# Work Order ID 95464

Item Name: Crosstube Low Standard Aft

DRAWING NO. D412-664-249	TITLE CROSSTUBE ASS'Y (412 LOW AFT)	REV. B	<b>DART AEROSPACE LTD ENGINEERING ORDER</b>		D.E.O. NO. D412-664-249-B-1	SHEET NO. SHEET 1 OF 2	SCALE NTS
DRAWN <i>q</i>	CHECKED <i>SC</i>	MFG. APPR. <i>E</i>	APPROVED <i>MD</i>	DE APPR. <i>MD</i>			
DATE 11.05.25	DATE 11.05.31	DATE 11.05.31	DATE 11/05/31	DATE 11.05.31

REMOVED ABRASION STRIP IN FAVOR OF A THIN LAYER OF PROSEAL 890.

**D412-664-249**  
**ASSEMBLY DETAIL**

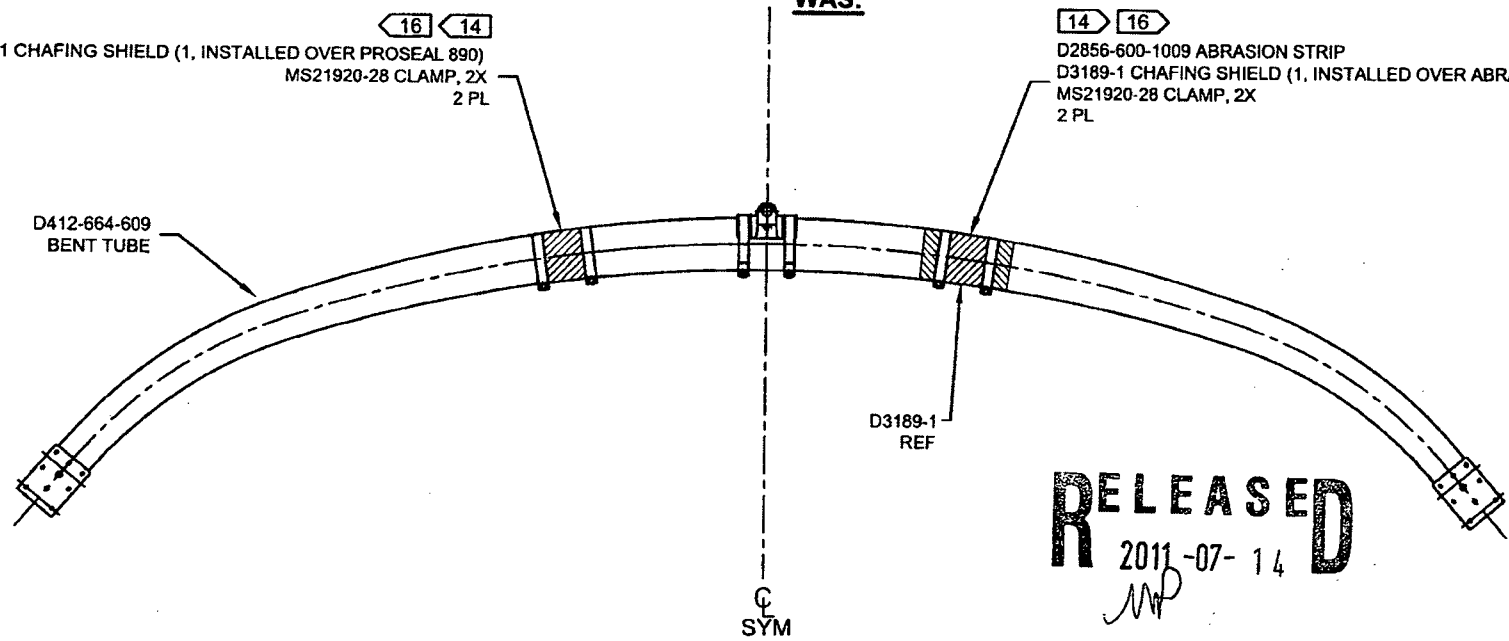
DRAWING NO. D412-664-249	TITLE CROSSTUBE ASS'Y (412 LOW AFT)	REV. B	DART AEROSPACE LTD ENGINEERING ORDER	D.E.O. NO. D412-664-249-B-1	SHEET NO. SHEET 2 OF 2	SCALE NTS
DRAWN JP	CHECKED Sc	MFG. APPR. E	APPROVED MD	DE APPR. H		
DATE 11.05.25	DATE 11.05.31	DATE 11.05.31	DATE 11/05/31	DATE 11.05.31

D2856-600-1009 ABRASION STRIP  
D3189-1 CHAFING SHIELD (1, INSTALLED OVER ABRASION STRIP)  
MS21920-28 CLAMP, 2X  
2 PL

IS:

D3189-1 CHAFING SHIELD (1, INSTALLED OVER PROSEAL 890)  
MS21920-28 CLAMP, 2X  
2 PL

**D412-664-249  
ASSEMBLY DETAIL**

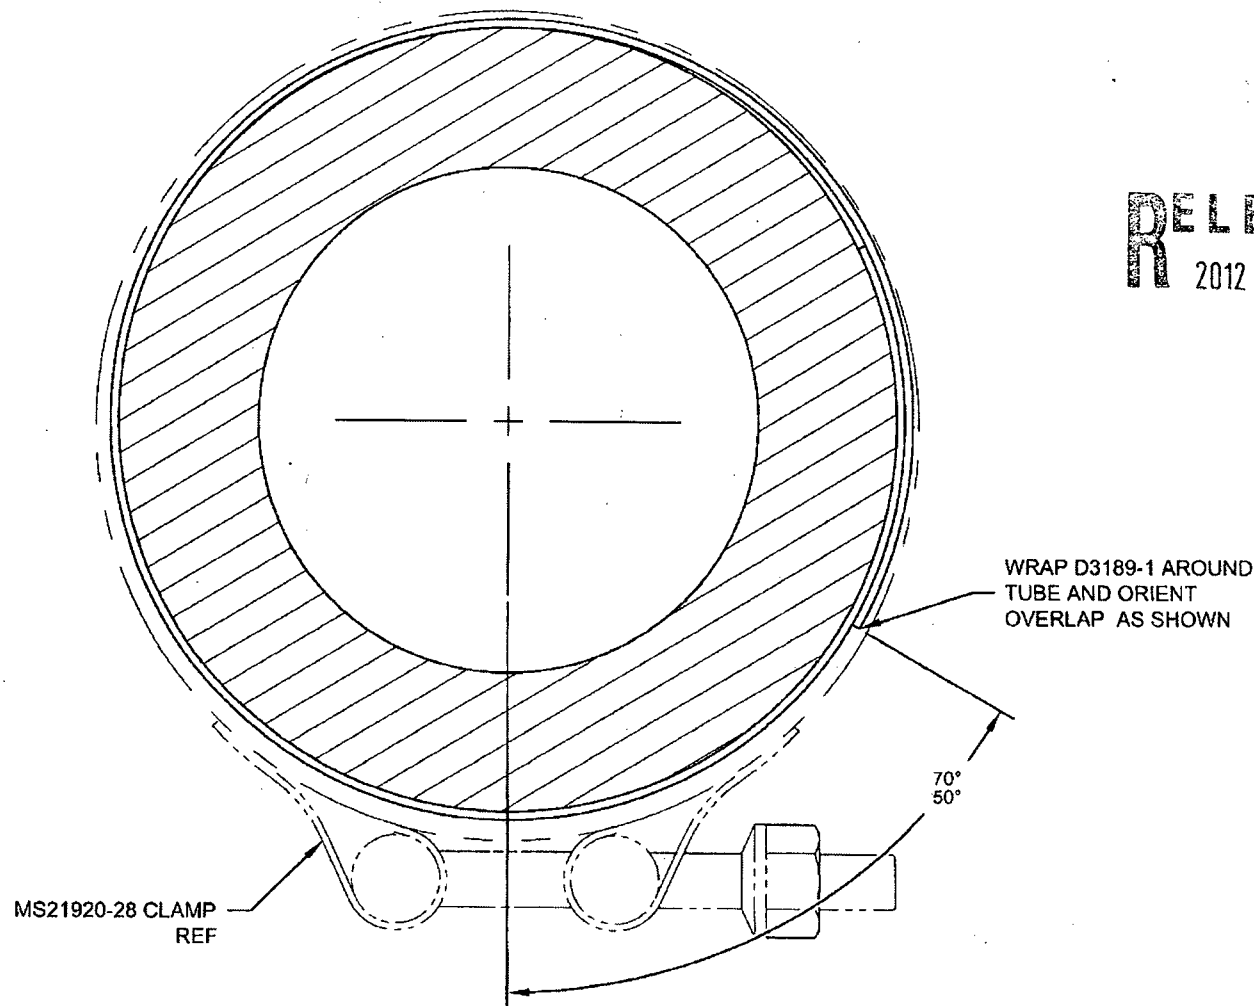
DRAWING NO. D412-664-249	TITLE CROSSTUBE (412 LOW AFT)	REV. B	DART AEROSPACE LTD ENGINEERING ORDER	D.E.O. NO. D412-664-249-B-3	SHEET NO. SHEET 2 OF 3	SCALE NTS
DRAWN 9P	CHECKED A	MFG. APPR. A	APPROVED MD	DE APPR. H		
DATE 12.08.21	DATE 12.08.22	DATE 12.08.29	DATE 12.08.29	DATE 12.08.29	DATE 12.08.29
